RE: Barelas Park Improvements Grading & Drainage Plan

**Hydrology File: K14D047**

Based upon the information provided in your submittal received 08/19/2021, the Grading & Drainage Plan **is not** approved for Grading Permit and Paving Permit. The following comments need to be addressed for approval of the above referenced project:

#### Sheet C-102

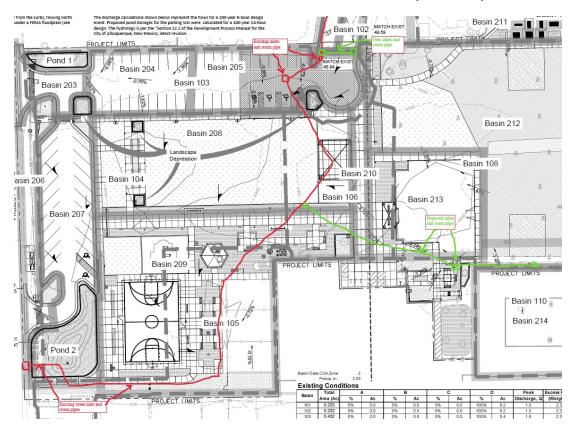
- 1. Please update the reference to the Development Process Manual (DPM). The current DPM (signed 06/08/20) for the procedure for 40 acre and smaller basins is outlined in Article 6-2(a). Please also correct any changes in the calculations. The Q<sub>100</sub> under the new DPM has been found to be less than the old DPM.

- 2. Please follow the DPM (signed 06/08/20) Article 6-12 Stormwater Quality and Low-Impact Development for the sizing calculations and provide the required calculations. To calculate the required SWQV, multiply only the proposed impervious area (buildings, sidewalks, and paving) draining to the BMP by 0.26 inches for redevelopment sites which this project falls under.

- 3. Please either provide a reference to the weir equations or provide the weir calculations, per DPM Article 6-16(A) for the curb cuts. A coefficient of 2.7 is typically used for the weir equation  $Q = CLH^{2/3}$ .

- 4. What could be helpful is showing the existing storm sewer and the proposed storm sewer on this overall map. I have highlighted the existing in red and the proposed in green. The existing I showed are from the City's GIS. There are some proposed lines that may need to be adjusted or abandoned if not going to be used anymore.

5. One thing that I was wondering that I am assuming is a shade structure at Basin 210. The existing parking lot appears to have been used as a ponding area with an inlet. Is this being removed?
